**June 4, 2012**

Ref N°: ACS2012-PAI-PGM-0152

**SUBJECT: APPLICATION TO ALTER 19 KINDLE COURT, A PROPERTY  
PROTECTED UNDER THE *ONTARIO HERITAGE ACT* AND LOCATED  
IN THE BRIARCLIFFE HERITAGE CONSERVATION DISTRICT  
STUDY AREA**

**DOCUMENT 3**

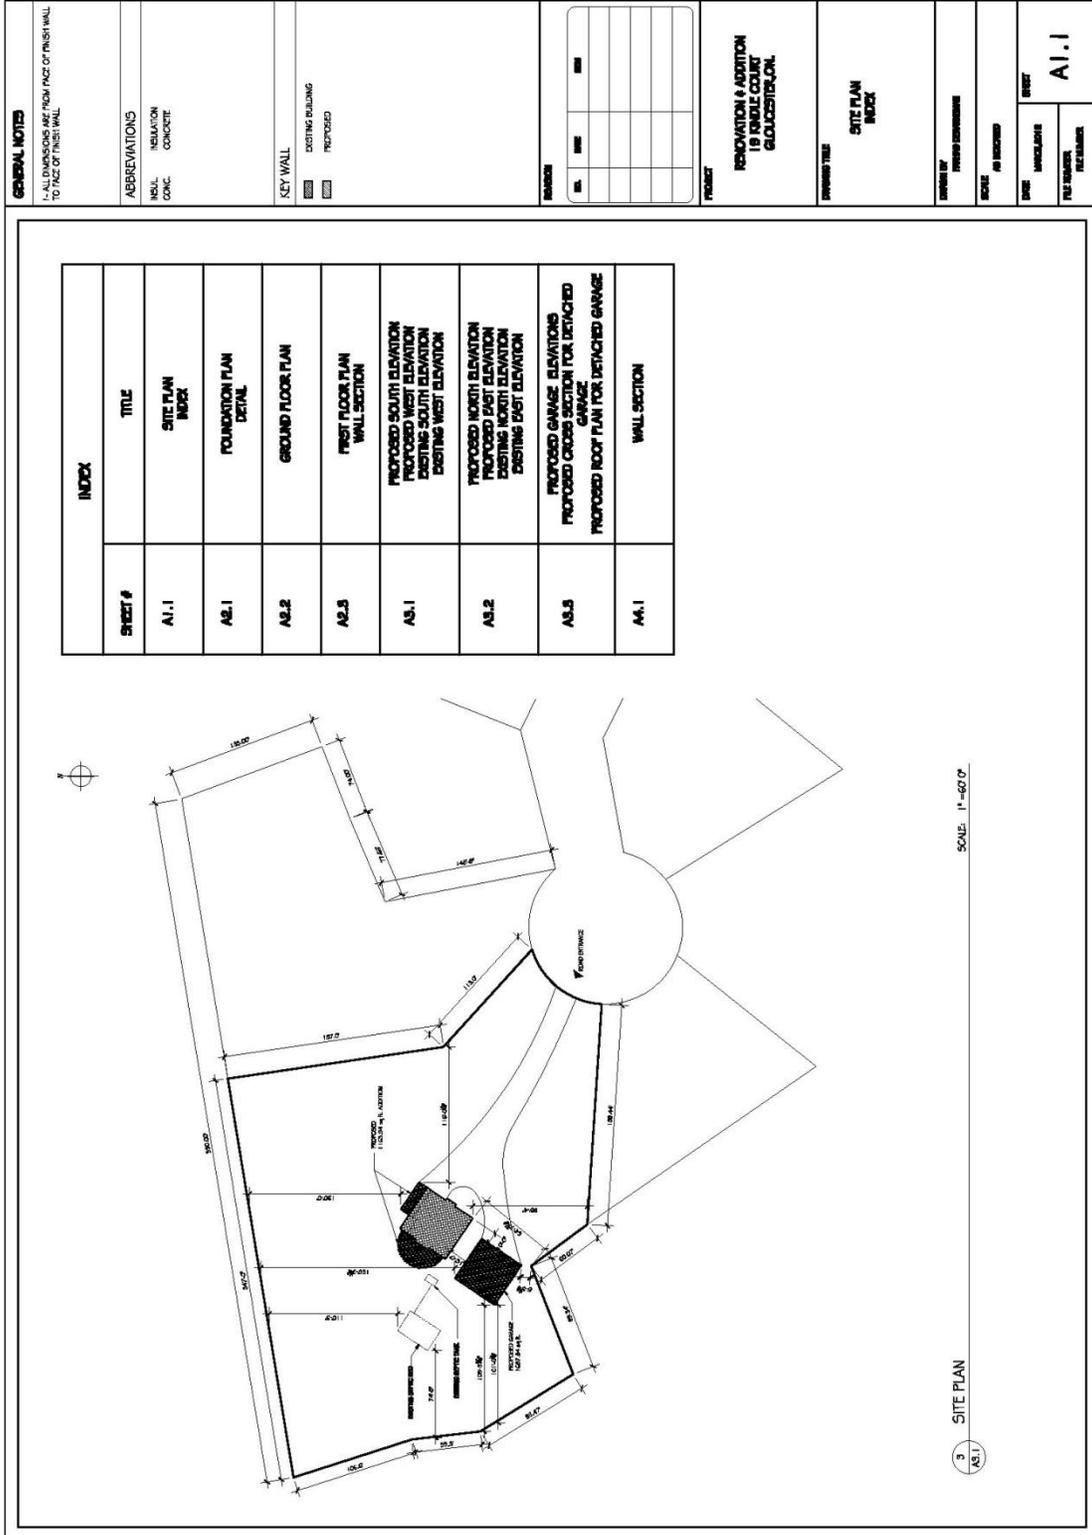
The proposed flat-roofed, stucco-clad, detached garage has three bays, two single car doors and one large garage door. The proposed garage is approximately 158 square metres in size. The proposed garage would require a minor variance to the Zoning By-law to permit an accessory building of 158 square metres where 55 square metres is permitted. The construction of the garage will result in the cutting of 11 mature deciduous trees (Documents 3, 5, 6)

The proposed garage does not meet Standard 11 because it is not subordinate to the existing house. While the garage is detached, the building footprint is almost the same as that of the main house.

The proposed garage does not meet the Guidelines for cultural landscapes as noted above because it is not compatible with the character of this lot or the neighbourhood as a whole. Most houses in the HCD Study Area have a single modestly sized carport or garage. Because of its size and the loss of 11 mature trees necessary for its construction, the proposed garage does not meet the Guideline that states that new additions to a cultural landscape should respect historic visual relationships in the cultural landscape. The proposed garage with a flat roof and stucco cladding is compatible in shape and materials but the scale and massing of the building are completely out of the character with the HCD Study Area.

For these reasons, the Department does not support the proposed garage.

DOCUMENT 4

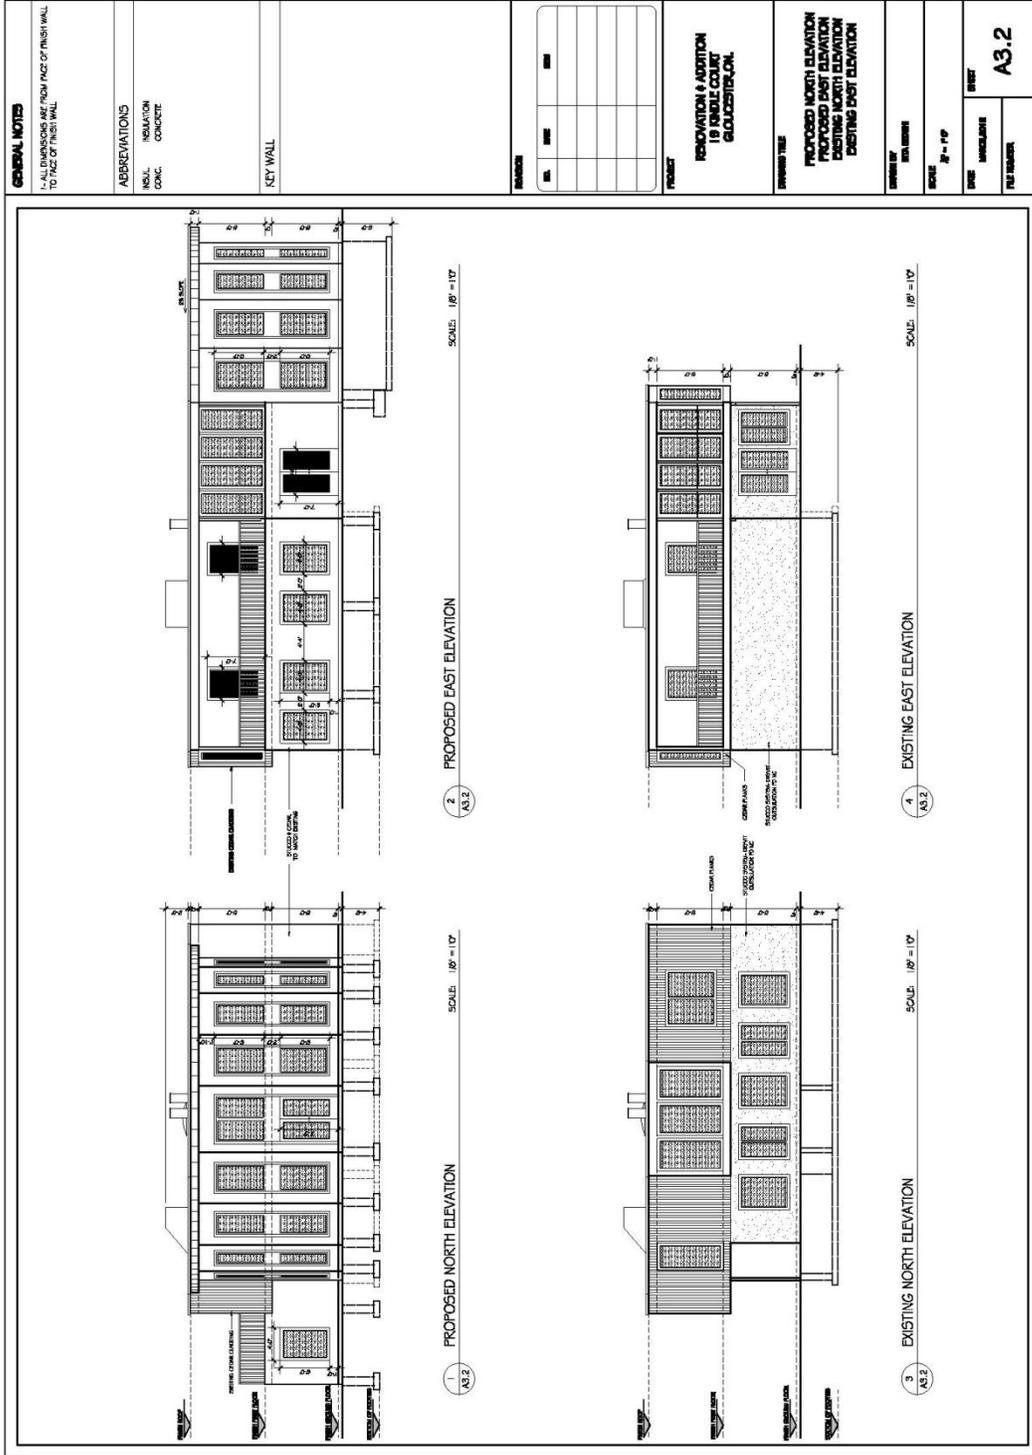
The application includes a large addition at the rear (north) of the house. This proposed addition at the rear of the building is a two storey, flat roofed structure that is semi-circular in form. It completely covers the existing rear façade of the house and is proposed to be clad in stucco. The addition has large windows and double doors leading to the rear yard (Documents 2, 3, and 4).

The proposed addition meets the guidelines related to the location. Its location at the rear of the building means that it is subservient to the original building. The proposed addition provides a clear distinction between new and old and the choice of materials is compatible with the existing building. However, the proposed semi-circular shape is not compatible with the original house.

The existing house is made up of rectangular forms and the proposed semi-circular addition deviates from this form. The proposed addition does not meet Standards 1 or 11 as noted above because the new addition will alter the character defining elements of the house, and the addition is not physically or visually compatible with or subordinate to the Duncan House.

The application also proposes a one storey addition at the east side of the house. The proposed addition would be located under the overhang of the upper storey and extend out from the lower storey. The addition would be clad in stucco (Document 4).

This addition does not meet the Standards or guidelines above because its location and massing compromises two of the character defining elements of the building; the front façade and the void created by the cantilevered upper storey. The east addition will fill

the void and change the proportions of the original building. Furthermore, the proposed addition is flush with the front façade of the existing house and will alter the proportions of the front façade.

The Department does not support the east side addition because it does not meet the Standards and Guidelines.

- 1. Approve the application for construction of a rear addition as per drawings  
submitted on May 22, 2012 and included as Document 4 subject to the shape**

of the rear addition being changed to rectangular instead of semi-circular and inset 60 cm from the east and west sides of the rear elevation;

2. Refuse the application for a one storey flat roofed addition at the east side of the building included in Document 4;
3. Refuse the application for the new garage as per the drawings attached in Document 5; and
4. Delegate authority for minor design changes to the General Manager, Planning and Growth Management Department.

The Department would support the addition at the rear of the house if it were rectangular in shape, and set in at least 60 cm from each side of the rear of the building. A rectangular addition would be visually compatible with the existing building and setting. Furthermore, setting the addition in at the rear of the building will allow the original house to remain the dominant feature in the landscape. The proposed stucco cladding and large windows are appropriate to the character of the existing building.
